San Diego Gas and Electric Company's
Proponent's Environmental Assessment for the East County Substation Project
Revisions Due to Changes in Critical Habitat

East County Substation Project

Figure 4.4-1: Critical Habitat Map (Revised December 2009)

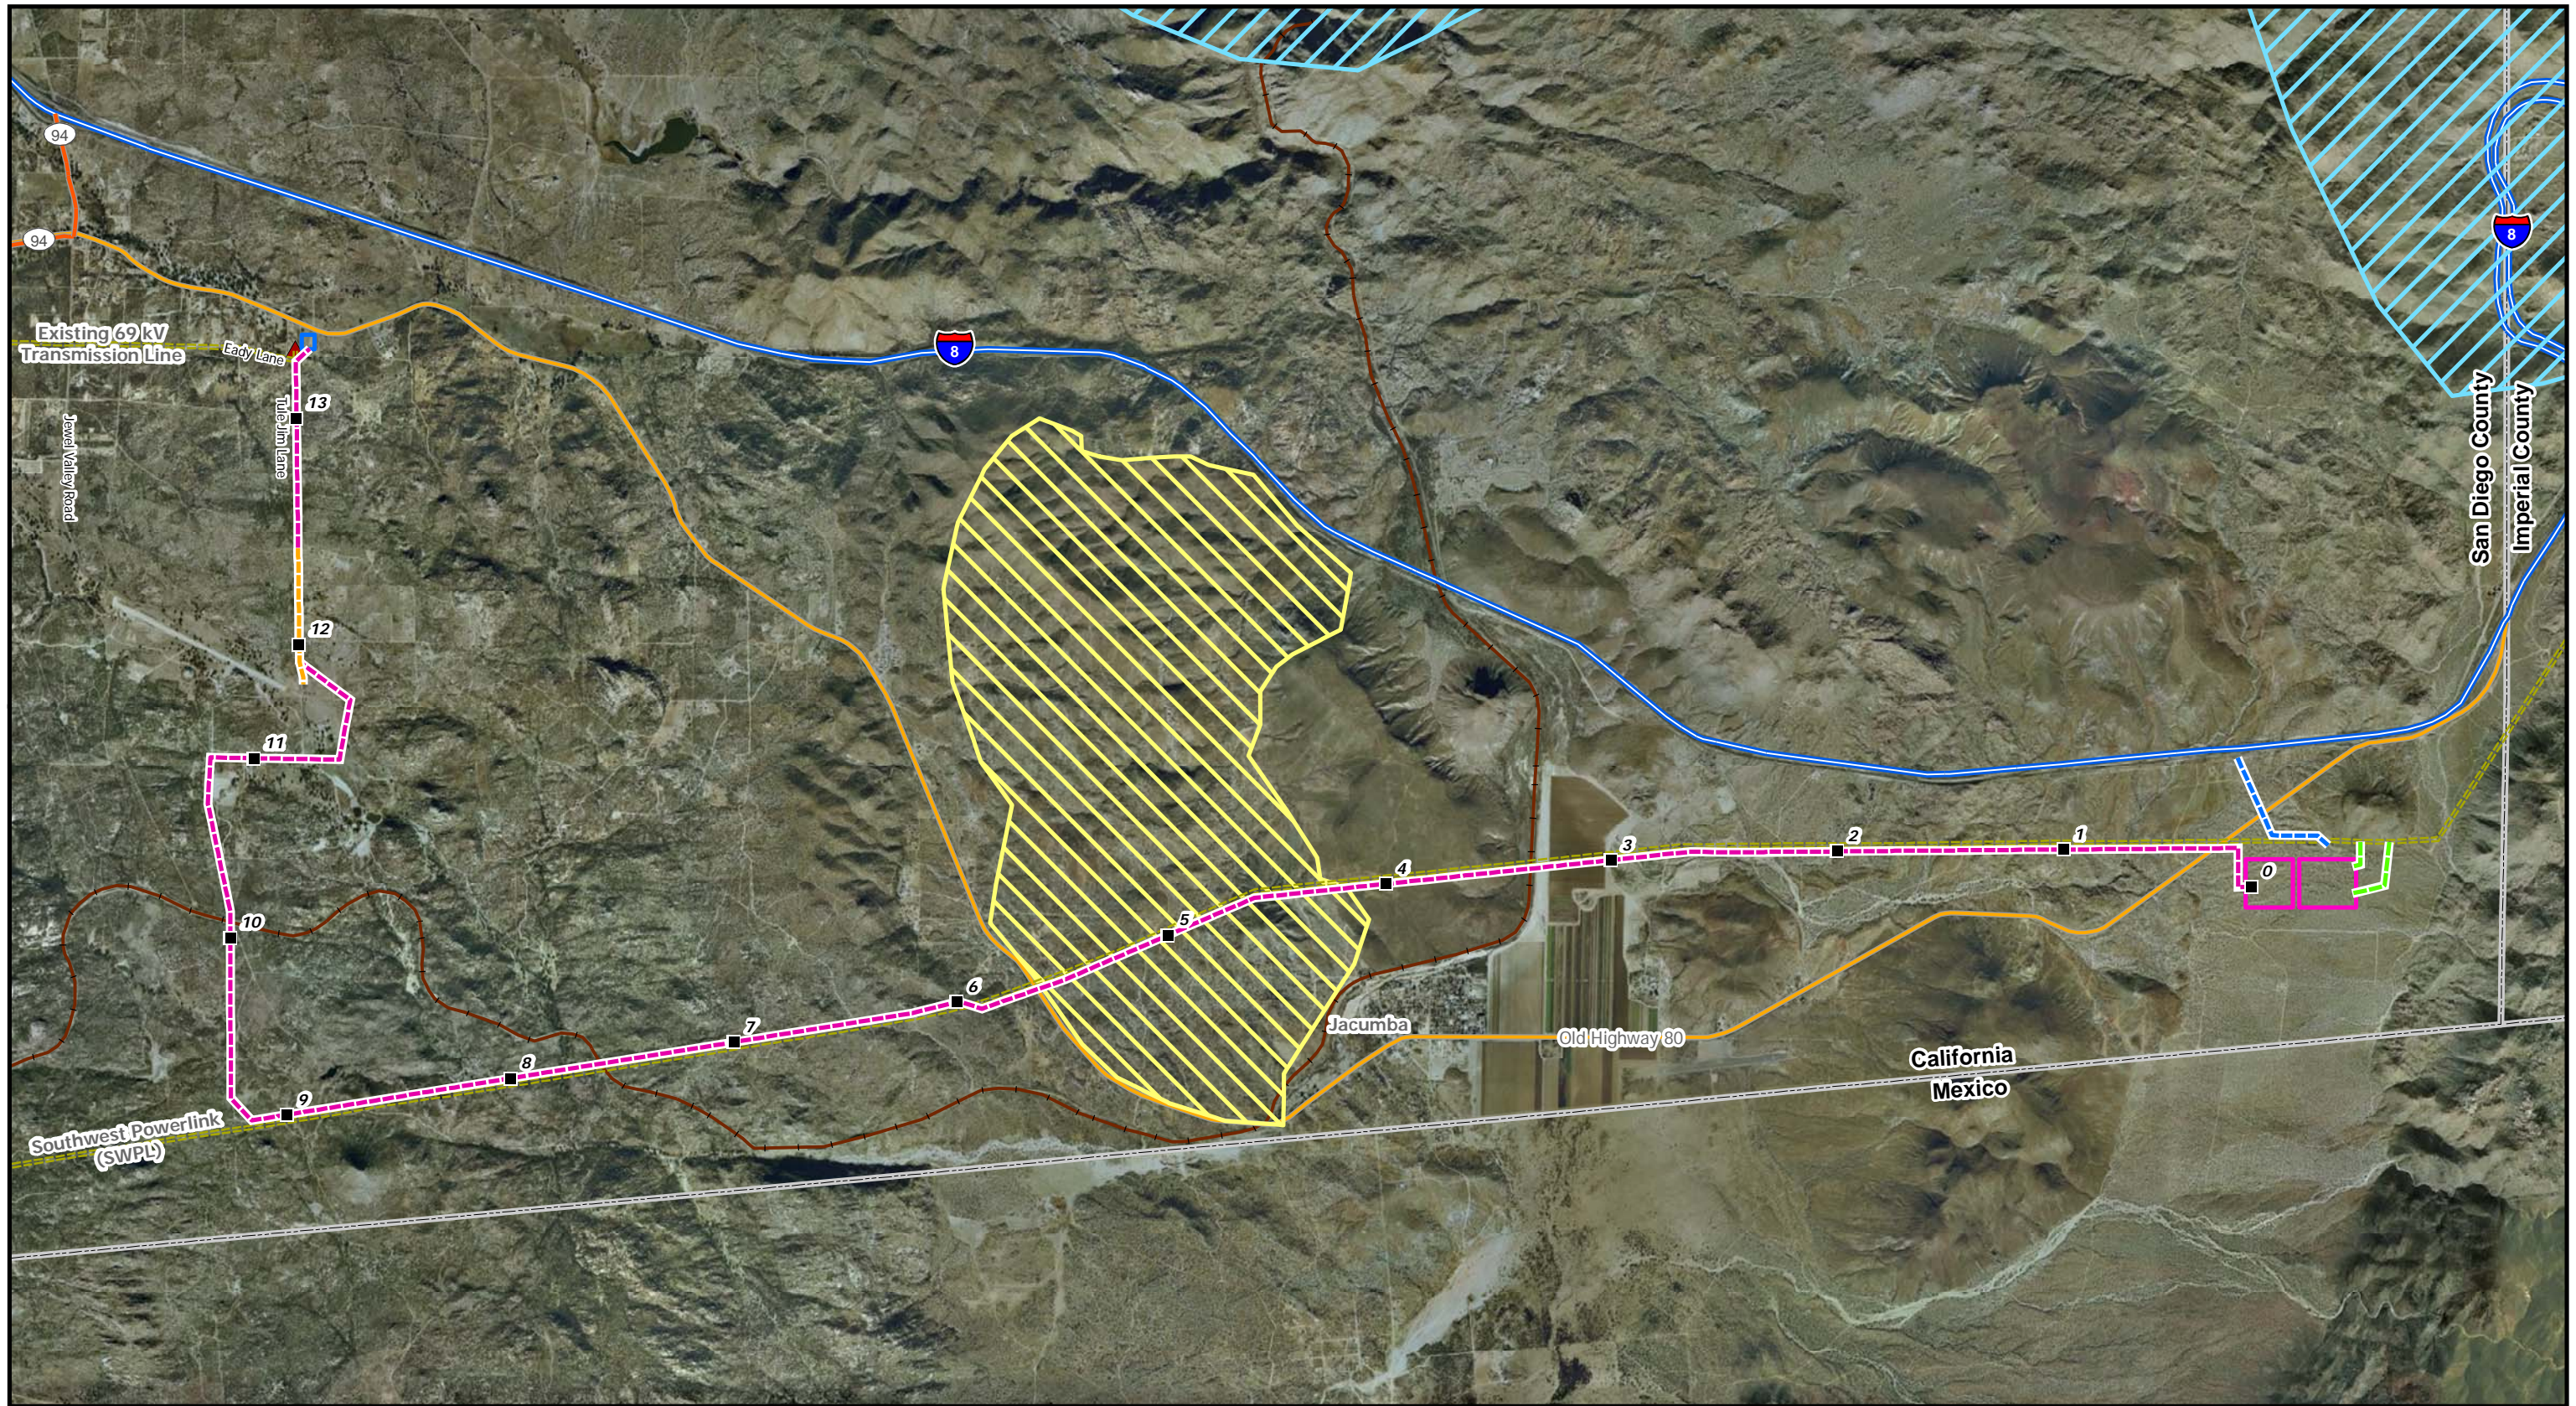
On June 17, 2009, the USFWS reduced the size of the QCB critical habitat from 171,605 acres to 62,125 acres. The area designated as the Jacumba Critical Habitat Unit, which the proposed 138 kilovolt (kV) transmission line crosses, was revised. A new map depicting the revised area designated as critical habitat for the QCB is attached and is intended to replace Figure 4.4-1 Critical Habitat Map within Section 4.4: Biological Resource of the PEA.

On April 14, 2009, the USFWS reduced the size of the PBS critical habitat from 844,897 acres to 376,938 acres. The portion of the PBS critical habitat east of the proposed ECO Substation was revised. A map depicting the new critical habitat for the PBS is attached

and is intended to replace Figure 4.4-1 Critical Habitat Map within Section 4.4: Biological Resource of the PEA.
